VENTURA UNIFIED SCHOOL DISTRICT

BID ADDENDUM NO. 1

ISSUED 3/21/2025

**PORTABLE TEAM ROOM
VENTURA HIGH SCHOOL
PROJECT NO. E12-25**

A-2.1

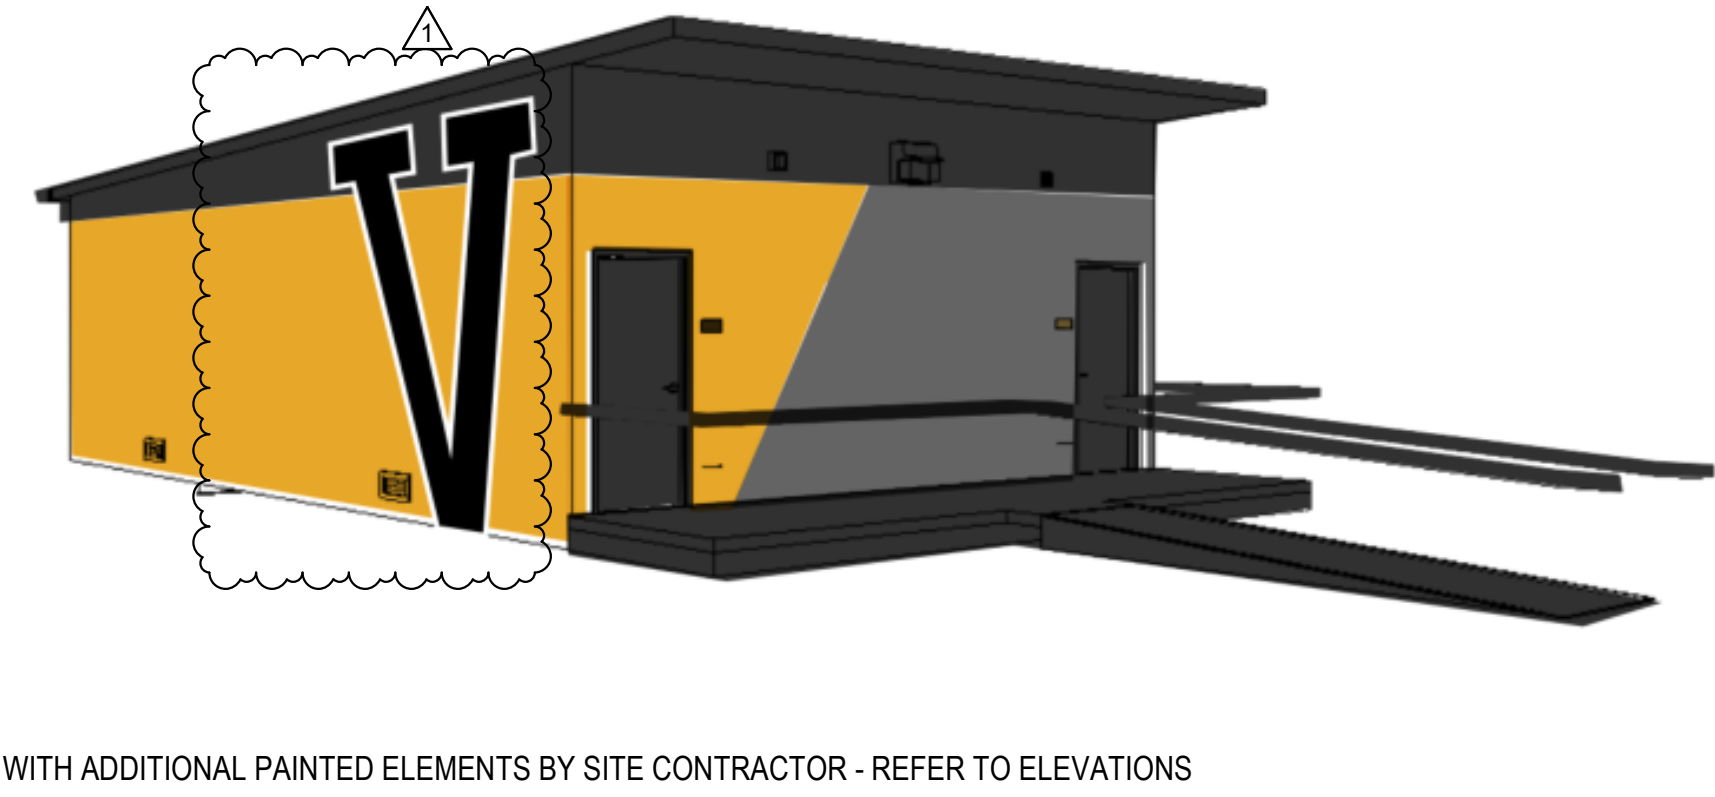
- Item 1 **Paint updates –**
A-2.1 – minor clarifications and adjustments and a new painted logo approach
- Item 2 **Accessible path updates –**
A-2.2 Included note for removal and reinstallation of existing bicycle parking.
Clarification of keynote 02-01.
- Item 3 **Electrical existing infrastructure updates –**
E-100, E-200 - Updated electrical site plan to reflect site infrastructure updates related to scoreboard project.

SITE PLAN - LANDING AND RAIL 1/2" = 1'-0" (10)

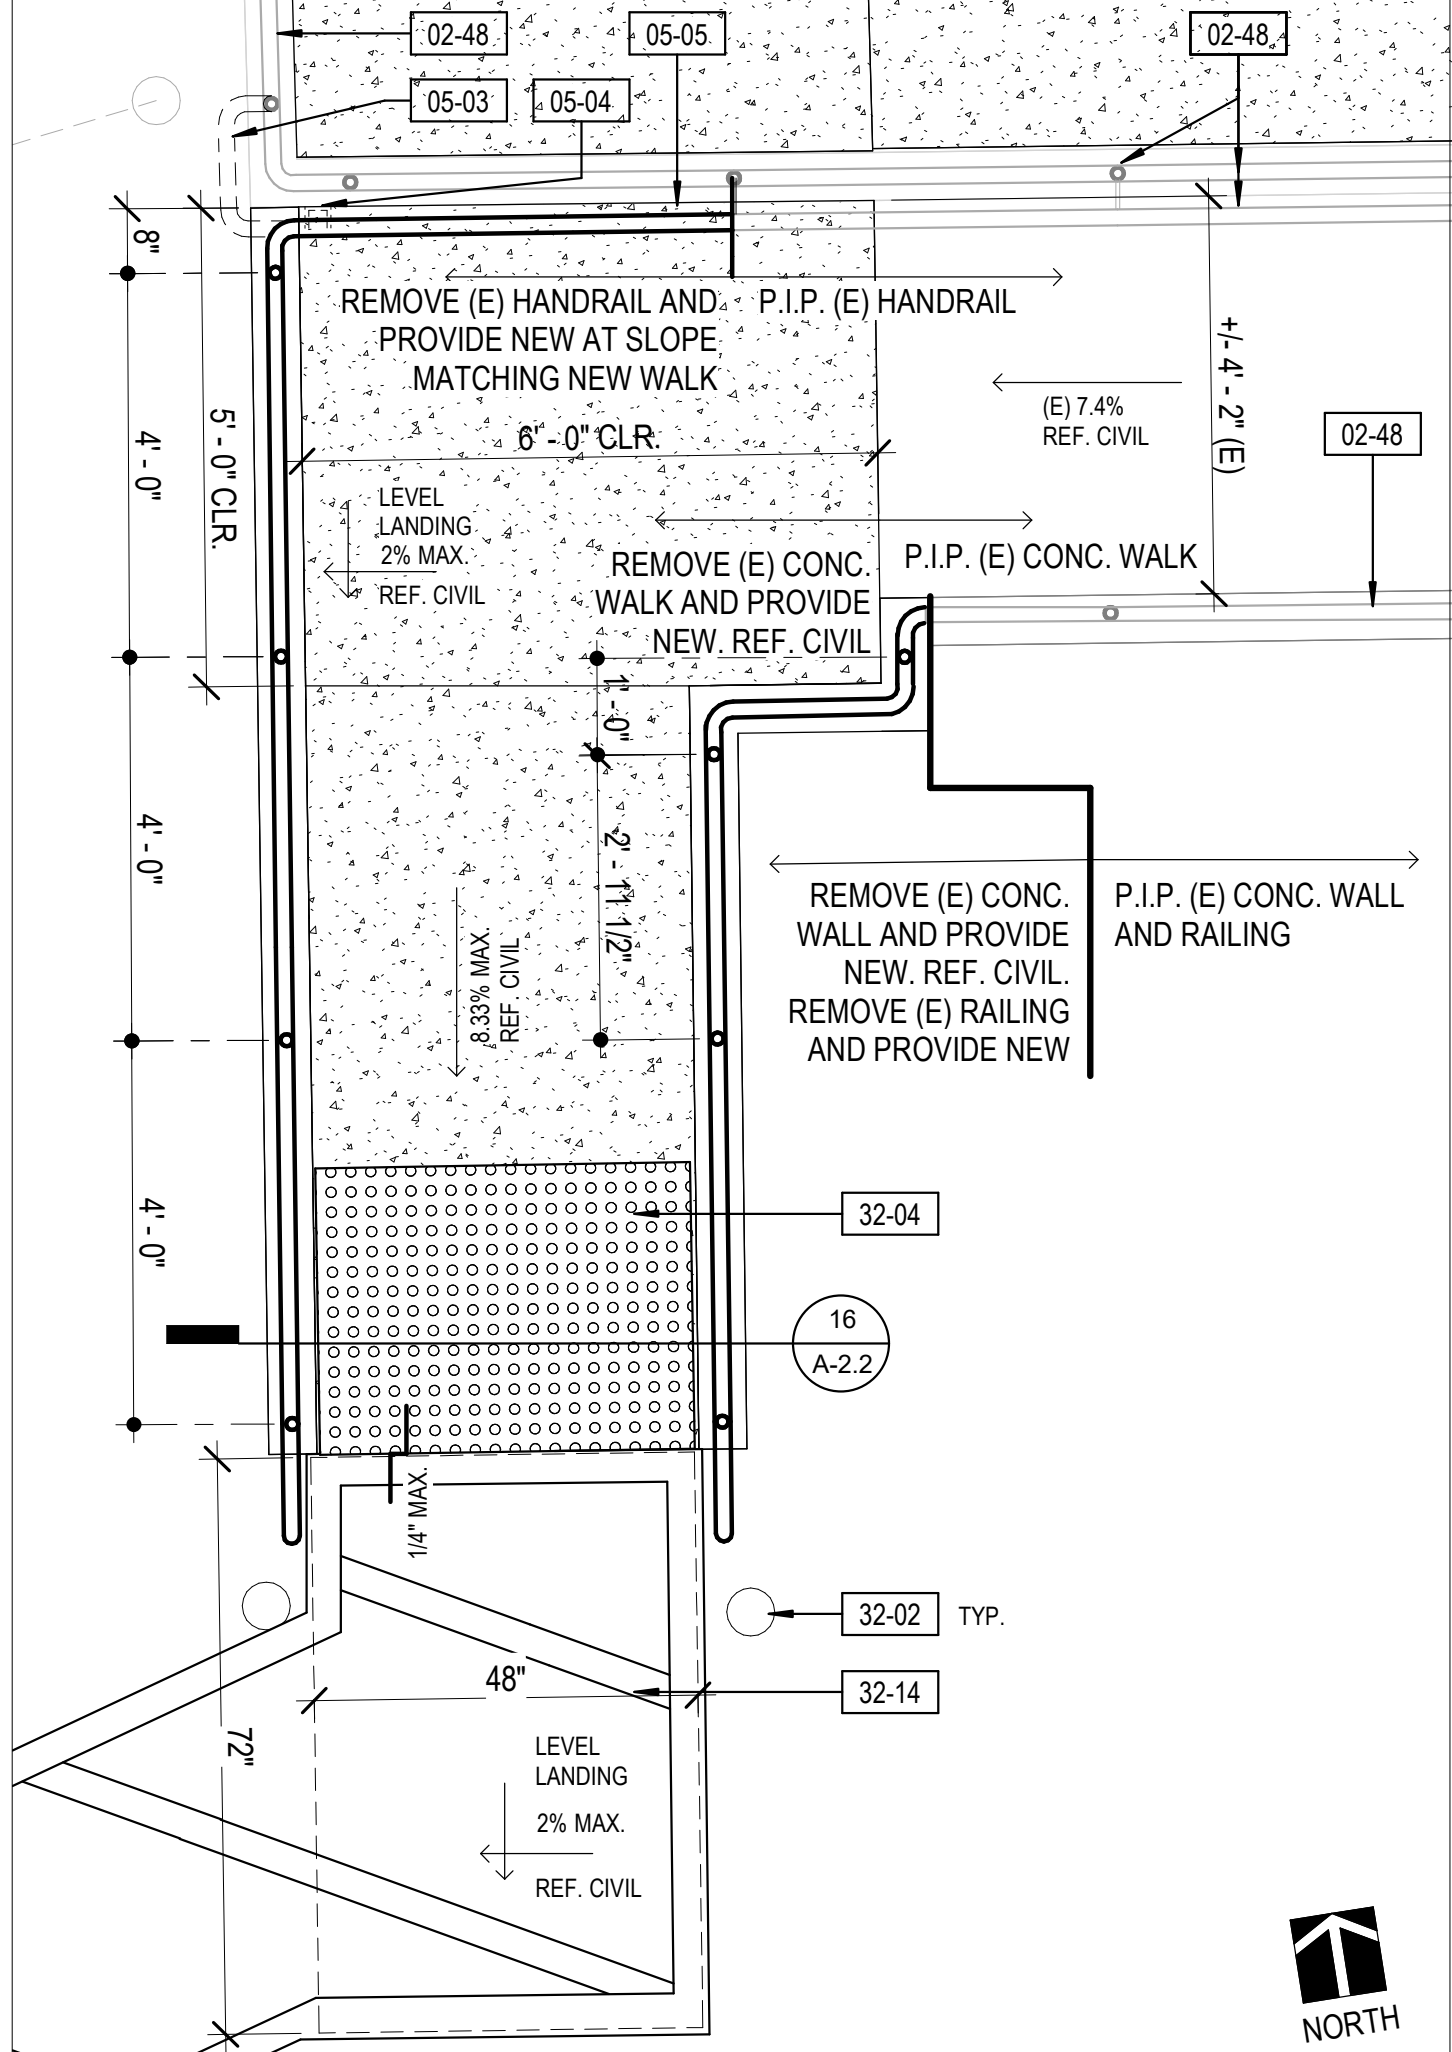
02-01	P.I.P. (E) ASPHALT AND STRIPING, SITE CONTRACTOR RESTRIPE
02-04	P.I.P. (E) DETECTABLE WARNING
02-10	P.I.P. (E) GATE
02-26	SITE CONTRACTOR REMOVE (E) BICYCLE PARKING, PROTECT AND REINSTALL
02-36	REMOVE (E) ACCESSIBLE PATH STRIPING
02-45	(E) ELECTRICAL LINE
02-47	(E) COMM LINE
02-48	P.I.P. (E) HANDRAIL AND CONCRETE WALL, TYP.
03-04	SITE CONTRACTOR CONSTRUCT 6" HIGH CONC. CURB
05-03	SITE CONTRACTOR REMOVE (E) HANDRAIL EXTENSION AND PATCH POST AT ATTACHMENT POINT, GRIND SMOOTH AND TOUCH UP GALVANIZATION
05-04	SITE CONTRACTOR REMOVE (E) HANDRAIL ANCHORAGE POINT AND PATCH (E) CONCRETE WALL
05-05	SITE CONTRACTOR REMOVE (E) HANDRAIL AND PROVIDE NEW AT SLOPE MATCHING NEW WALK, WELD TO (E), GRIND SMOOTH AND REPAIR GALVANIZATION
05-06	SITE CONTRACTOR TOUCH UP COLD GALVANIZED JOINTS ON EXISTING GALVANIZED RAILINGS
05-07	SITE CONTRACTOR SAWCUT AND REMOVE (E) RAILING AND STANCHIONS AND 6" CONCRETE CURB.
05-08	SITE CONTRACTOR RESTORE CONTINUOUS CONNECTION BETWEEN NEW RAIL AND (E) RAIL. SITE CONTRACTOR RESTORE CONTINUOUS CONNECTION BETWEEN NEW RAIL AND (E) HAND RAIL.
